From: Tim Townsend [REDACTED]
Sent: 05 March 2018 11:05
To: Planning.Responses
Cc: Michael Eastham; Gary Markwell; Juliet Harris [REDACTED]
Subject: LU/278/17/RES - Southern By-Pass, Toddington - Approval of reserved matters - WSCC Highways response dated 5th March 2018

WEST SUSSEX COUNTY COUNCIL
PLANNING SERVICES CONSULTATION

SUBJECT: LU/278/17/RES - Approval of Reserved Matters following Outline Permission LU/47/11 for Construction of the southern section of the Lyminster Bypass, including northern and southern roundabouts, surface water drainage and landscaping. Departure from the Development Plan & affects a Public Right of Way.

SUBMISSION TO WEST SUSSEX COUNTY COUNCIL FOR DEPARTURES FROM STANDARD

A/PHLYM - DD - HDD1

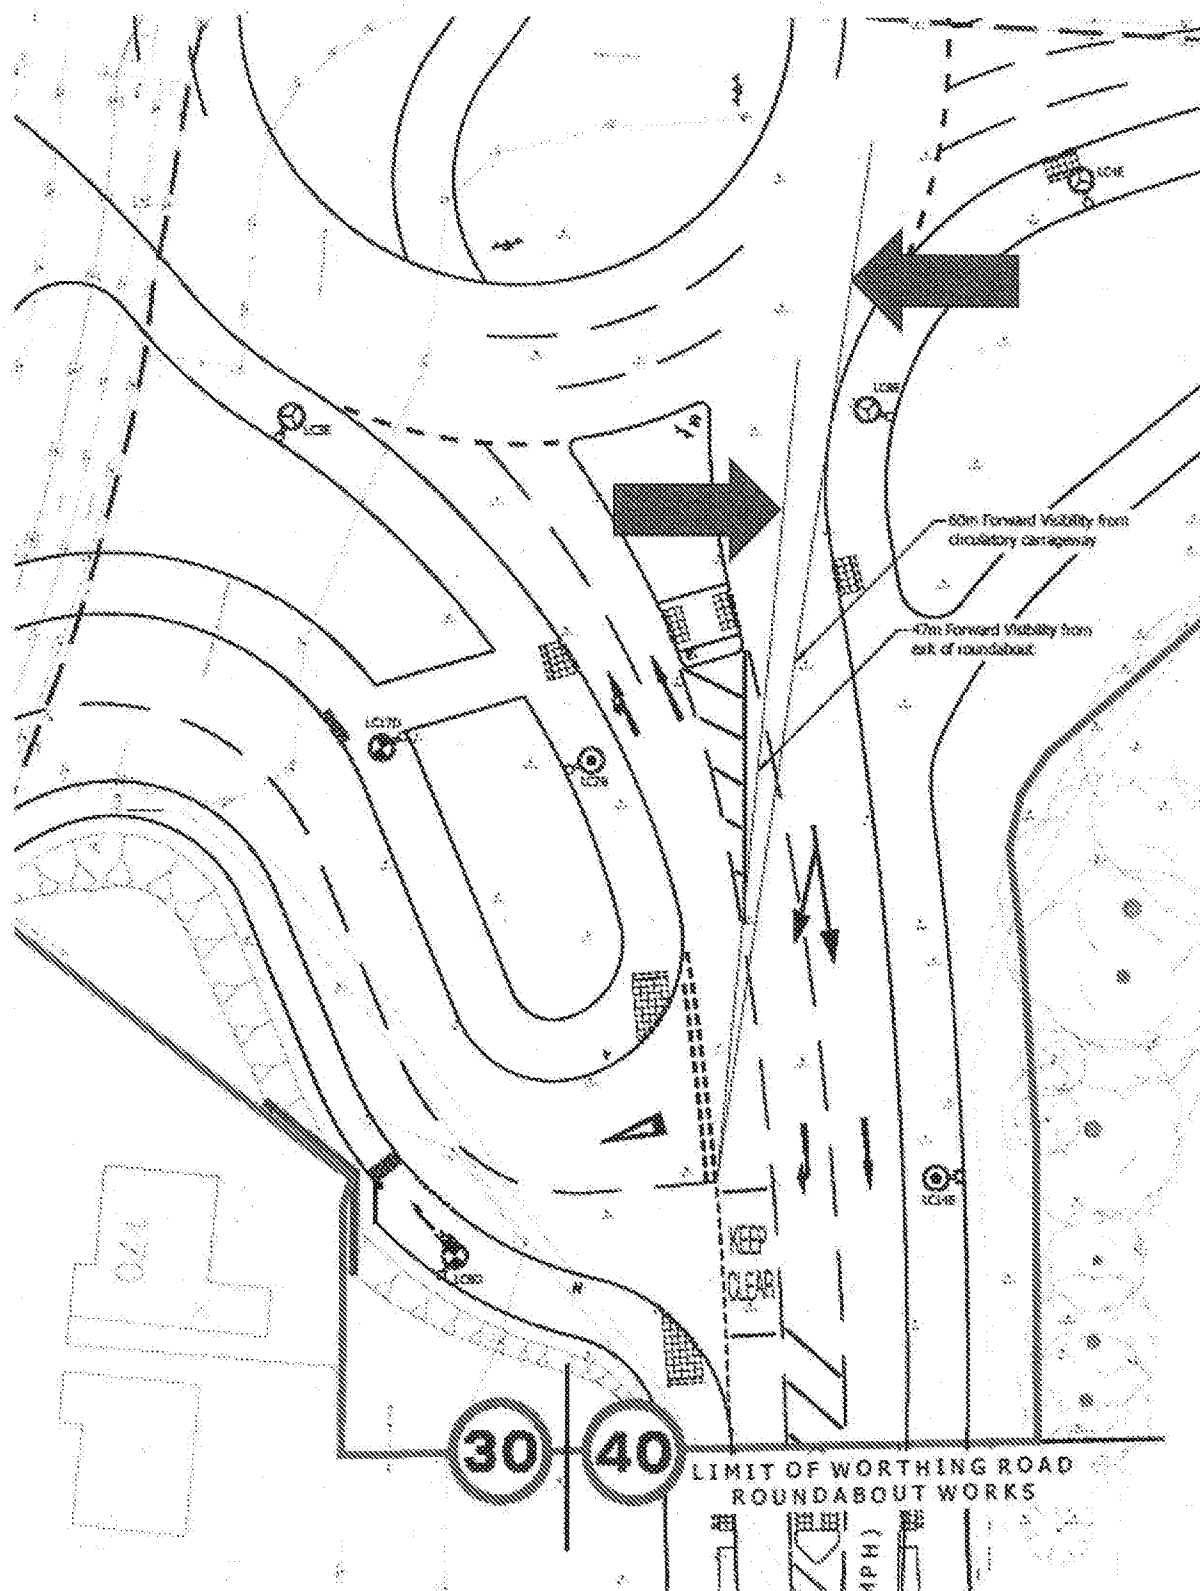
A	Discipline	Road Geometry
	Type	Ghost Island Right Turn Priority Junction - Major Road Southbound Approach Forward Visibility
B	Relevant Standard(s)	TD42/95
	Clause	7.4/7.5 - Major Road
C	Difference Between Standard(s) and proposed design	7.4 Drivers approaching a major/minor priority junction from both the major road and the minor road shall have unobstructed visibility as indicated in the following sections. The envelope of visibility for driver's eye height is as set out in TD 9 (DMRB 6.1.1.2.2). 7.5 Drivers approaching a major/minor priority junction along the major road approaches shall be able to see the minor road entry from a distance corresponding to the Desirable Minimum Stopping Sight Distance (SSD) for the design speed of the major road, as described in TD 9 (DMRB 6.1.1). This visibility allows drivers on the major road to be aware of traffic entering from the minor road in time for them to be able to slow down and stop safely if necessary. Design speed is 70kph (40mph). 120m forward visibility is required. 47m (from roundabout exit) forward visibility is achievable approaching the junction from the north, approx. 60m from Roundabout circulatory carriageway.

D	Reason for Departure (overview)	The space available for the A259 roundabout is very limited. It is not possible to incorporate Highdown Drive into the roundabout. Highdown Drive has therefore been realigned in order to form a priority junction with the Fitzalan Link. This has been placed as far as possible to the south of the roundabout. Speeds for southbound vehicles leaving the roundabout are likely to be 30mph or less.

A	Safety	A reduction in forward visibility could increase the potential of vehicles not seeing the junction in time and failing to give way. Speeds for southbound vehicles leaving the roundabout are likely to be 30mph or less.
B	Congestion/ Delay	
C	Environmental / sustainability	The proposed arrangements allow for an all movements access junction with Fitzalan Link.
D	Capital and whole life cost/value	
E	Accessibility	
F	Integration	
G	Structural	
H	Network resilience & Maintenance

Major Road Southbound Approach Forward Visibility – 47m from exit of roundabout not 120m

NAME 2	ALEX SHARKEY.		
ROLE	MANAGER HIGHWAYS PROJECTS.		
SIGNED		DATE	19/2/18.
MARK ONE BOX:	1- APPROVED ☒	2-APPROVED WITH COMMENTS ☐	3- REJECTED ☐
COMMENTS

A/PHLYM - DD - HDD2

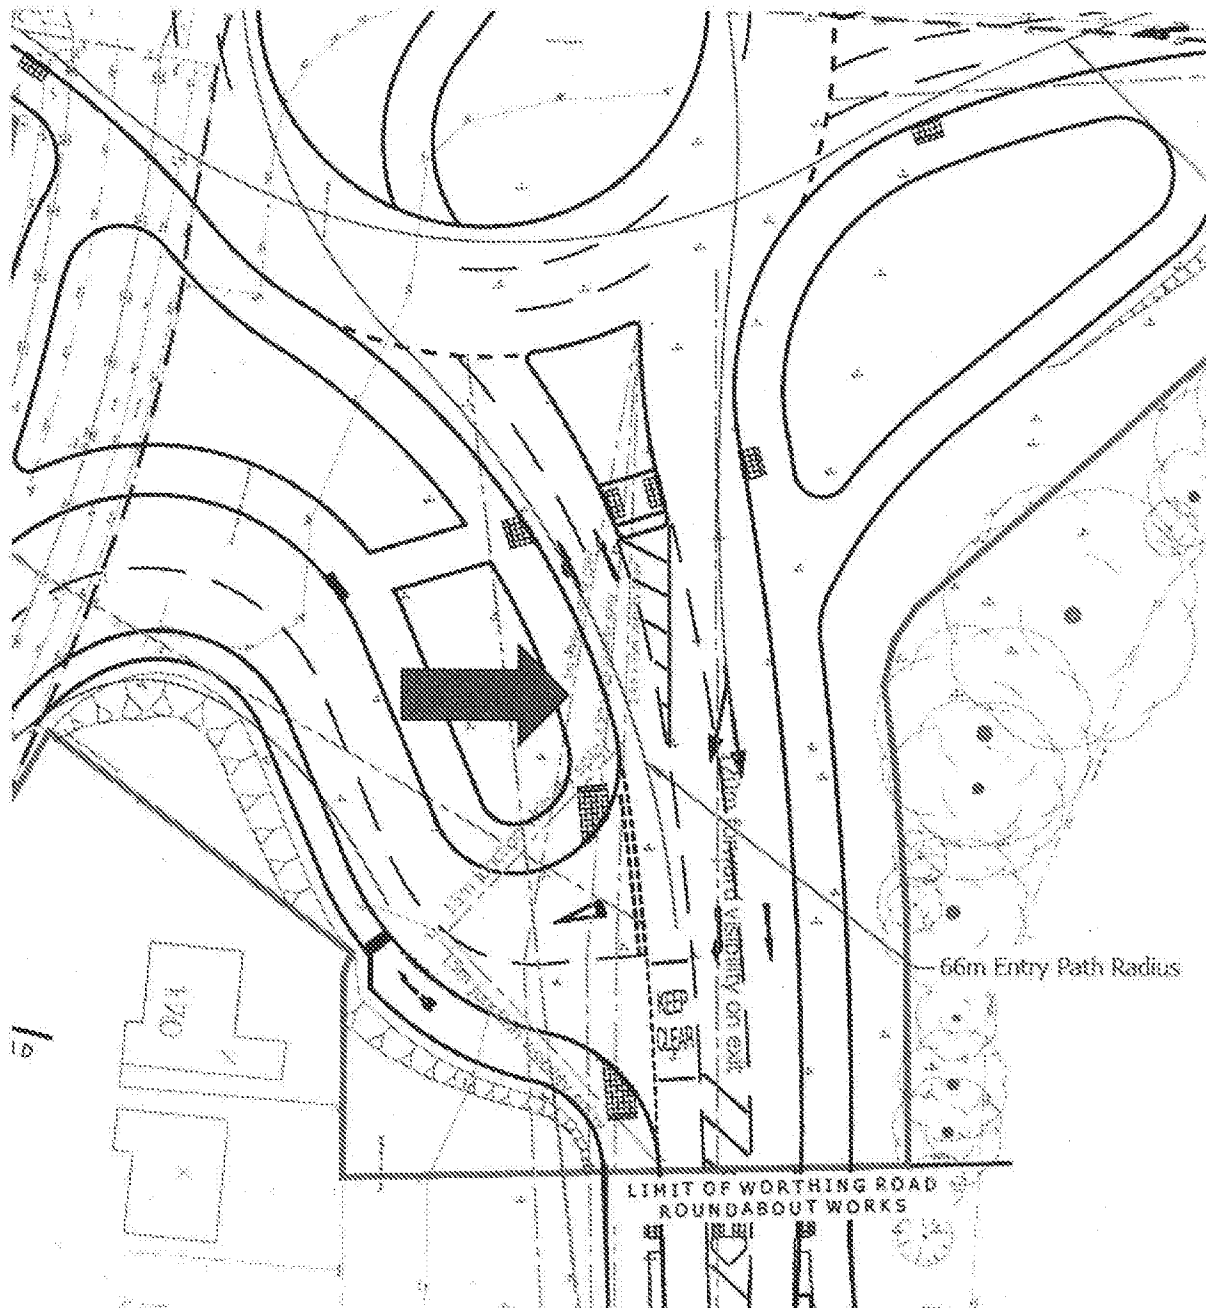
A Discipline	Road Geometry
Type	Ghost Island Right Turn Priority Junction - Minor Road visibility 'y' distance looking left
B Relevant Standard(s)	TD42/95
Clause	7.6(c) - Minor Road
C Difference Between Standard(s) and proposed design	7.6 (c). The distance back along the minor road from which the full visibility is measured is known as the 'x' distance. It is measured back along the centreline of the minor road from the continuation of the line of the nearside edge of the running carriageway of the major road. The 'x' distance shall be desirably 9m (but see para 7.8). From this point an approaching driver shall be able to see clearly points to the left and right on the nearer edge of the major road running carriageway at a distance given in Table 7/1, measured from its intersection with the centreline of the minor road. This is called the 'y' distance and is defined in Fig 7/1. Relaxations are not available for this distance. 70kph = 120m from Table 7/1 Actual achievable = approx 45m to roundabout exit.

D Reason for Departure (overview)	The space available for the A259 roundabout is very limited. It is not possible to incorporate Highdown Drive into the roundabout. Highdown Drive has therefore been realigned in order to form a priority junction with the Fitzalan Link. This has been placed as far as possible to the south of the roundabout. Speeds for southbound vehicles leaving the roundabout are likely to be 30mph or less.
E Associated Project Departures	A/PHLYM - DD - HDD1, 3 and 4

A	Safety	Vehicles turning right out of the junction may not see vehicles travelling southbound and cause a collision. Speeds for southbound vehicles leaving the roundabout are likely to be 30mph or less.
B	Congestion/ Delay	
C	Environmental / sustainability	The proposed arrangements allow for an all movements access junction with Fitzalan Link.
D	Capital and whole life cost/value	
E	Accessibility	
F	Integration	
G	Structural	
H	Network resilience & Maintenance

Minor Road - Visibility 'y' distance - 45m not 120m

NAME 2	P. A. SHARKEY		
ROLE	MANAGER HIGHWAYS PROJECTS.		
SIGNED			19/2/18.
MARK ONE BOX:	1- APPROVED ☐	2- APPROVED WITH COMMENTS ☒	3- REJECTED ☐
COMMENTS

Note the 'x' distance is in fact a departure, not a relaxation as described.

Wscce has generic approval for this departure that may be used at any ghost island junction except those between A and/or B roads. DFS1/3 refers

Ford Mondeo Mk3 visibility 'x' distances

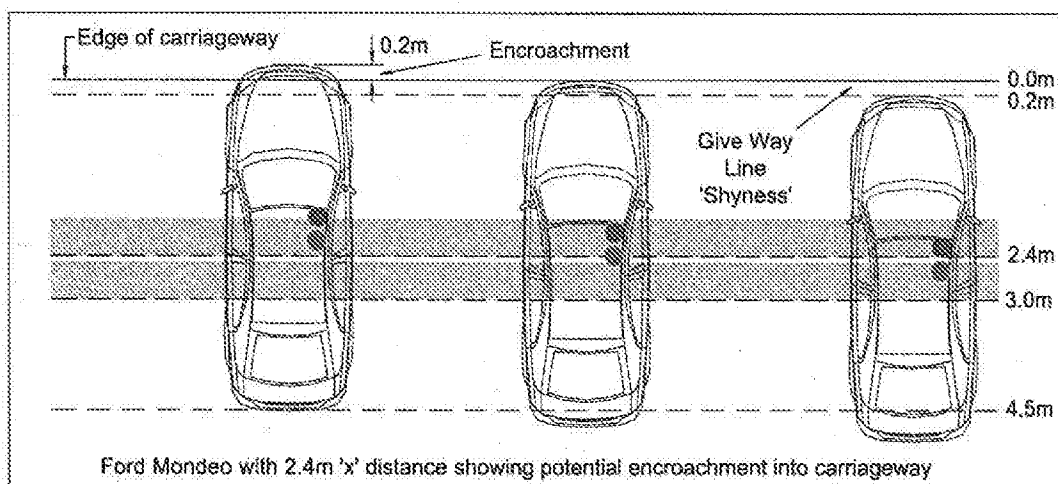
A	Discipline	Road Geometry
	Type	Junctions
B	Relevant Standard(s)	TD 42/95
	Clause	Para 7.8
C	Difference Between Standard(s) and proposed design	Standard requires 9m 'x' distance. No relaxations are permitted. Proposed design allows a departure to 4.5m.
D	Reason for Departure (overview)	Manual for streets states that full visibility is not required in low speed urban environments and suggest 2.4m is sufficient in most situations. The TD42/95 standard of 9m is deemed excessive on a County Road. Large (4.5 to 9m) 'x' distances are required for capacity reasons only and they may still be required where capacity assessments suggest they are necessary. Recent appeal decisions have confirmed that a requirement for larger 'x' distances are unlikely to be supported by the Inspector where capacity is not a key issue.
E	Associated Project Departures	This generic departure may be applied where there are other associated project departures, provided it is referred to in section E of the departures application. For the purposes of this note, where Manual for Streets is deemed applicable as set out in the WSCC Local Design Guide, the use of Manual for Streets 'y' distances are not considered to be Departures from Standards.

A	Safety	4.5m is sufficient for visibility provided vegetation is not allowed to encroach into the visibility splay.
B	Congestion/ Delay	These matters will be considered separately on a case by case basis.
C	Environmental / sustainability	The proposals will result in less sterilisation of otherwise developable land.
D	Capital and whole life cost/value	N/A
E	Accessibility	N/A
F	Integration	N/A
G	Structural	N/A
H	Network resilience & Maintenance	It is essential that adjacent vegetation is maintained appropriately.

NAME 1	David Lambert		
ROLE	Principal Engineer, Implementation Team, Strategic Planning		
SIGNED		DATE	16/7/2015
NAME 2	Alex Sharkey		
ROLE	Improvements Manager, Engineering Solutions		
SIGNED		DATE	27/7/2015
MARK ONE BOX:	1- APPROVED ☒	2-APPROVED WITH COMMENTS ☐	3- REJECTED ☐
COMMENTS

A/PHLYM - DD - HDD3

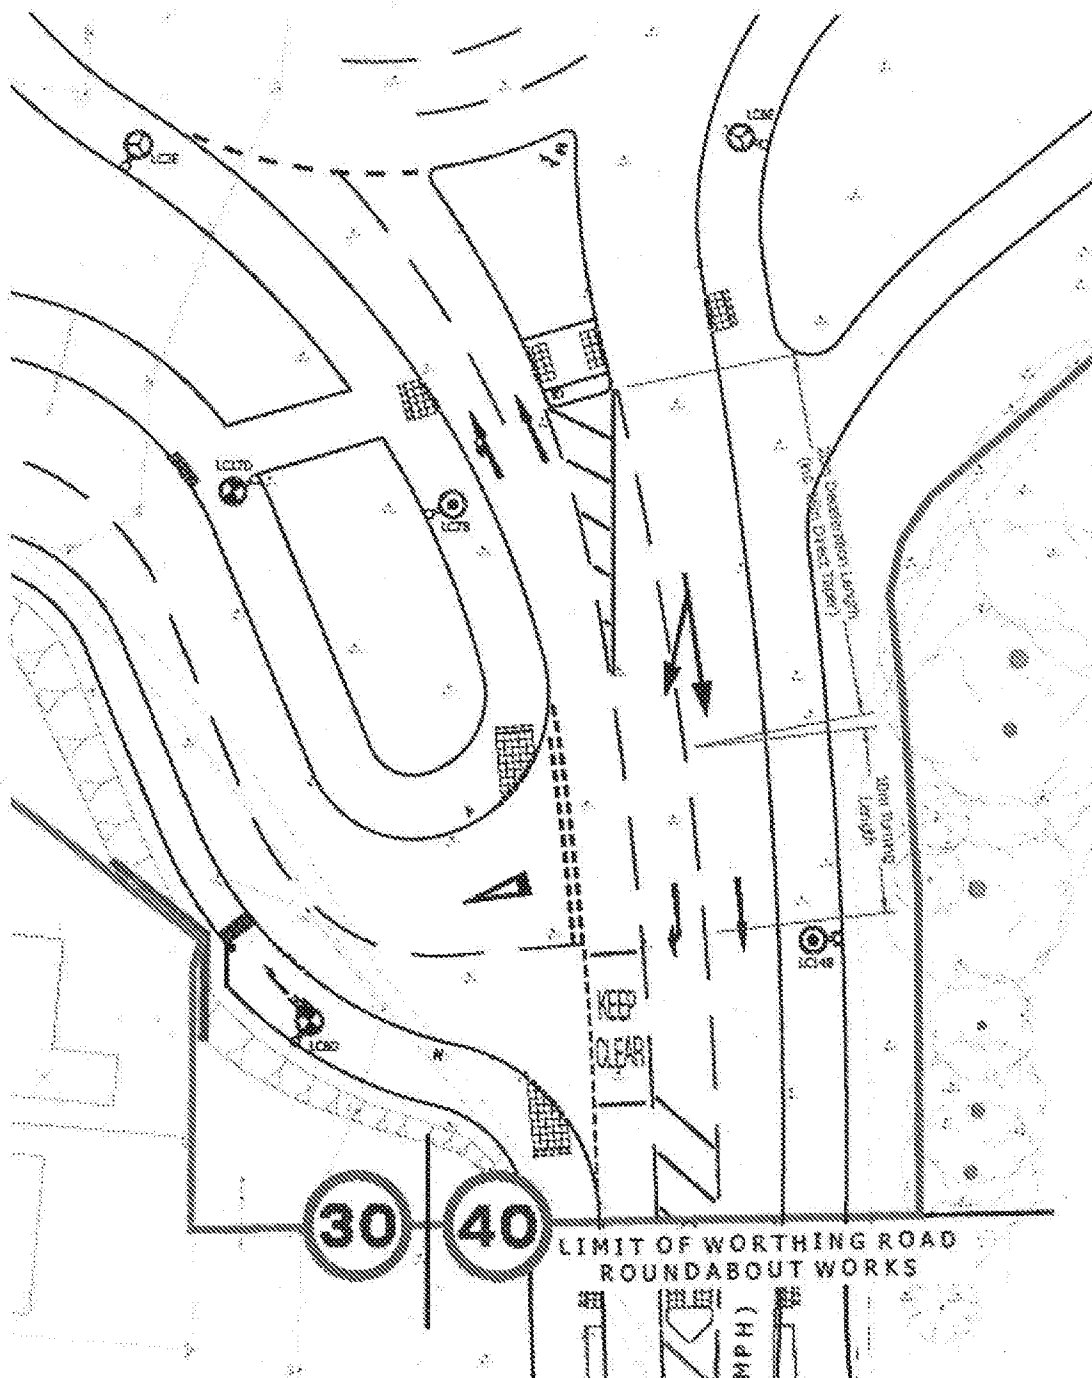
A	Discipline	Road Geometry
	Type	Ghost Island Right Turn Priority Junction - Deceleration length on right turn lane
B	Relevant Standard(s)	TD42/95
	Clause	7.40
C	Difference Between Standard(s) and proposed design	Right Turning Lanes 7.40 The overall length of a right turning lane provided at ghost island, single lane dualling and dual carriageway junctions, will depend on the major road design speed and the gradient. It consists of a turning length, as described in paras 7.32 and 7.33, and a deceleration length. This component shall be provided in accordance with Tables 7/5a and 7/5b, in which the gradient is the average for the 500m length before the minor road. Table 7/5a - Deceleration Length 40m (gradient 0 to 4%) Achievable deceleration length is 20m.
D	Reason for Departure (overview)	The space available for the A259 roundabout is very limited. It is not possible to incorporate Highdown Drive into the roundabout. Highdown Drive has therefore been realigned in order to form a priority junction with the Fitzalan Link. This has been placed as far as possible to the south of the roundabout. Speeds for southbound vehicles leaving the roundabout are likely to be 30mph or less. The right turn length has been reduced to accommodate an uncontrolled pedestrian crossing south of the roundabout, as requested by WSCC and to accommodate all movements at the junction. 20m is achievable, which is closer to the 60kph design speed that requires 25m.

A	Safety	Potential for rear end shunt accidents in right turn lane. Speeds for southbound vehicles leaving the roundabout are likely to be 30mph or less.
B	Congestion/ Delay	
C	Environmental / sustainability	The proposed arrangements allow for an all movements access junction with Fitzalan Link.
D	Capital and whole life cost/value	
E	Accessibility	
F	Integration	
G	Structural	
H	Network resilience & Maintenance

Major Road - Right turn lane deceleration length - 20m not 40m

NAME 2	P.A. SHARKE		
ROLE	MANAGER HIGHWAYS PROJECTS		
SIGNED		DATE	19/2/18
MARK ONE BOX:	1- APPROVED ☒	2-APPROVED WITH COMMENTS ☐	3- REJECTED ☐
COMMENTS

A/PHLYM - DD - HDD4

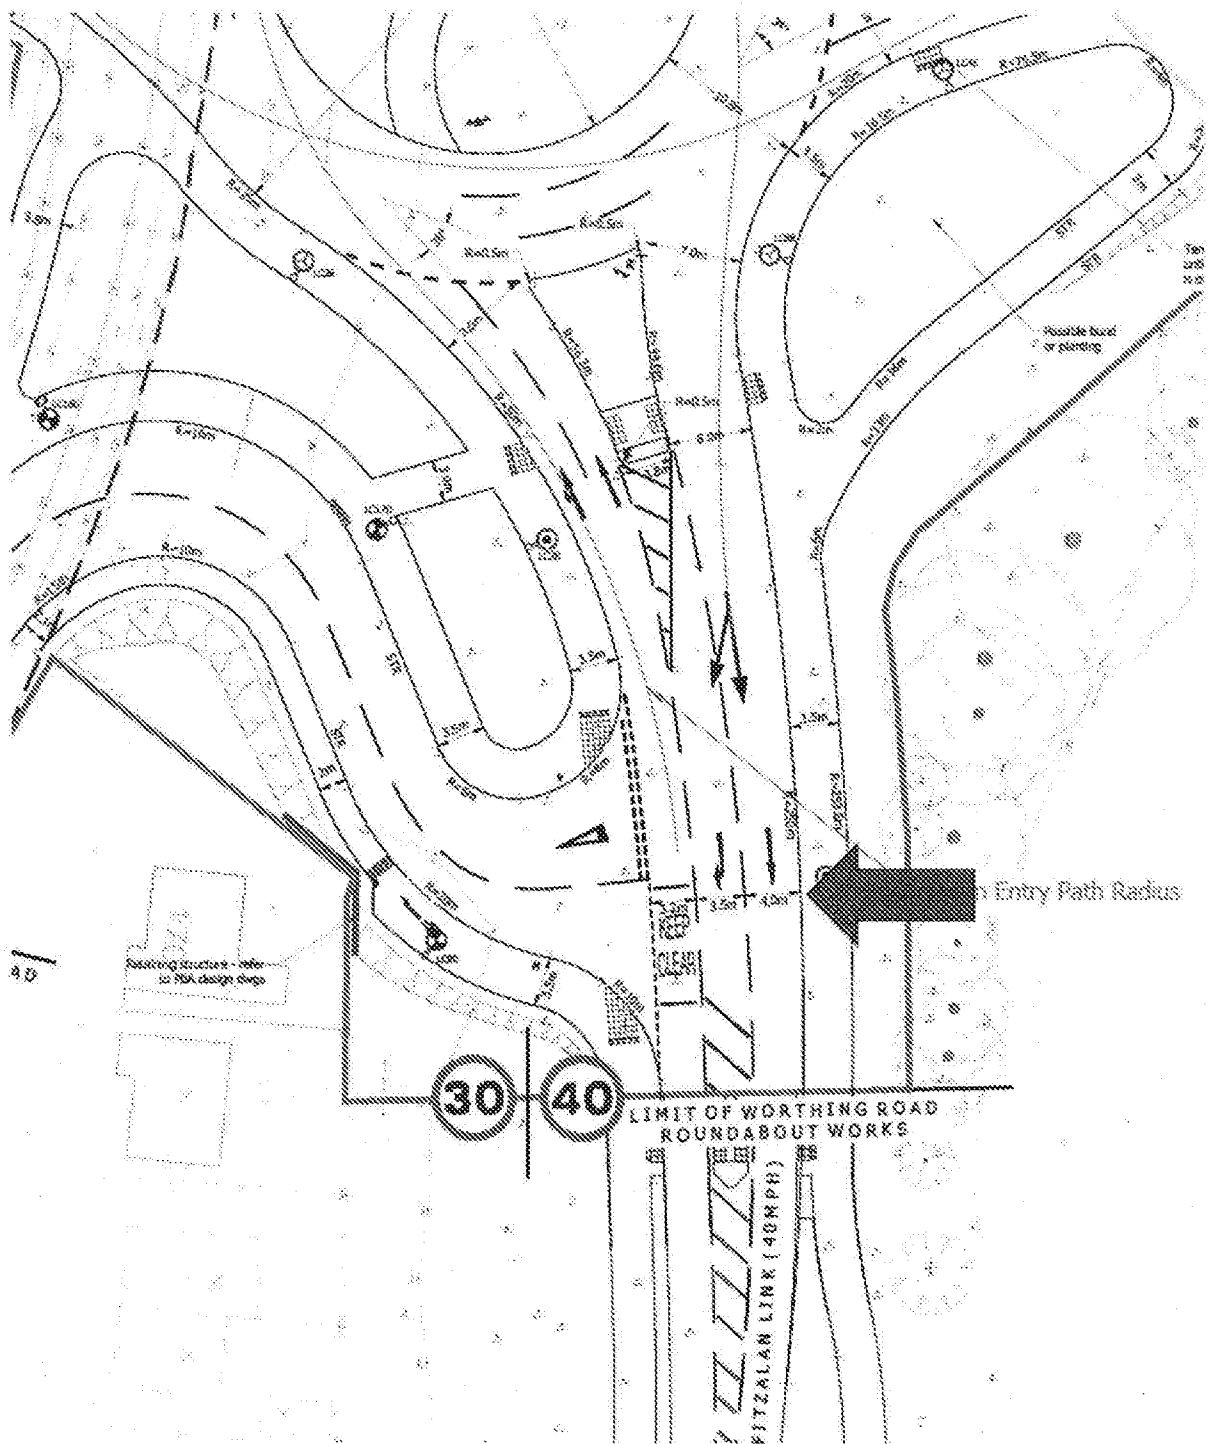
A Discipline	Road Geometry
Type	Ghost Island Right Turn Priority Junction - Through lane width
B Relevant Standard(s)	TD42/95
Clause	7.20
C Difference Between Standard(s) and proposed design	Through Lanes 7.20 At ghost island junctions, the through lane in each direction shall not be greater than 3.65m wide, exclusive of hardstrips, but shall not be less than 3.0m wide.
D Reason for Departure (overview)	The space available for the A259 roundabout is very limited. It is not possible to incorporate Highdown Drive into the roundabout. Highdown Drive has therefore been realigned in order to form a priority junction with the Fitzalan Link. This has been placed as far as possible to the south of the roundabout. Speeds for southbound vehicles leaving the roundabout are likely to be 30mph or less. The south bound lane tapers from 6m at the end of the traffic island to single lane width at a rate of 1 in 15 to 1 in 20 in accordance with TD16 Para 7.63. The right turn lane occurs within the taper length and thus the southbound through lane at the point of turn is 4m, which is in excess of the maximum 3.65m specified.

A	Safety	Potential for excess speed through the junction, although this is limited being so close to the exit from the roundabout. Possible southbound vehicles merging in proximity to right turn lane causing rear shunt or side swipe accidents. Speeds for southbound vehicles leaving the roundabout are likely to be 30mph or less.
B	Congestion/ Delay	
C	Environmental / sustainability	The proposed arrangements allow for an 2 lane exit from the roundabout with merge in accordance with TD16.
D	Capital and whole life cost/value	
E	Accessibility	
F	Integration	
G	Structural	
H	Network resilience & Maintenance

Major Road - Southbound through lane width 4m (which is greater than max 3.65m)

MARK ONE BOX:	1- APPROVED ☒	2-APPROVED WITH COMMENTS ☐	3- REJECTED ☐
COMMENTS
